TO: Internal File
THRU: Daron R. Haddock, Permit Supervisor *DRH*
FROM: Gregg A. Galecki, Sr. Reclamation Specialist/Hydrology *GA*
RE: Technical Field Visit, Plateau Mining Corporation, Star Point Mine, C/007/006

TECHNICAL FIELD VISIT

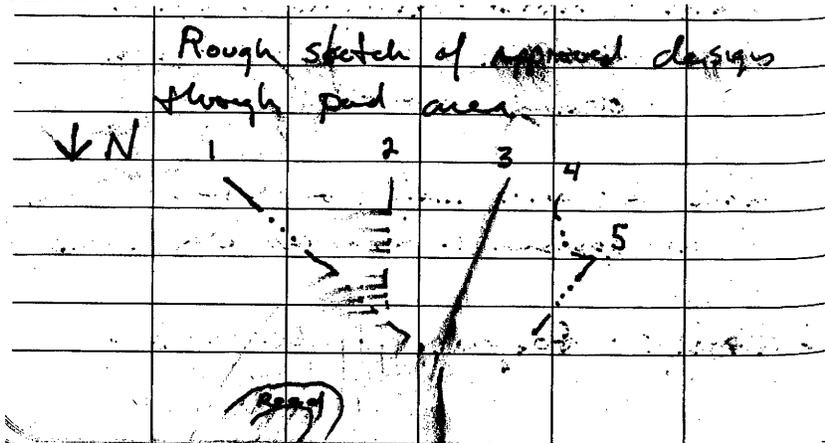
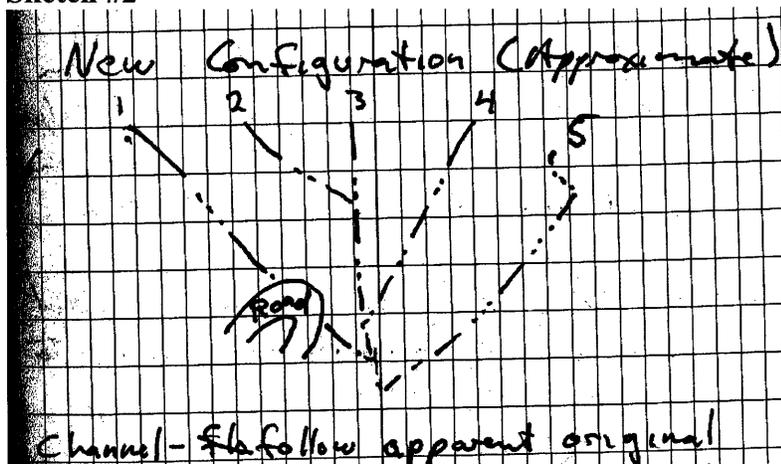
- Channel #1 will be a riprap channel and follows the apparent original drainage through the pond area and ties into the original drainage below the road.
- Channel #2 will possibly flow over bedrock as opposed to the riprap channel. A trench will be excavated on the level area above the pad site to help determine the depth to bedrock and the best location for the channel.
- Channel #3 will follow the drainage pattern currently established. There will be two 'plunge pools' located over bedrock outcrops. Between the two plunge-pools the channel will flow over bedrock if sufficient bedrock exists. A riprap channel will be used if bedrock does not exist.

- Channel #4 will likely be constructed with 'pyramat' fabric as long as the drainage fits the 'pyramat' design specs.
- Channel #5 – The area was too steep and cost-prohibitive to place a riprap channel down the 'fall-line'. An established channel exists at the toe of the slope that will be incorporated into the design. To use the existing channel, a short, well-armored riprap channel will need to be constructed to connect the undisturbed and existing channels.

The above-cited changes will likely be implemented. The changes will be submitted as 'as-built' modifications. Continued site visits are encouraged by the Operator and it is highly recommended to be continued by Division personnel to ensure quality reclamation.
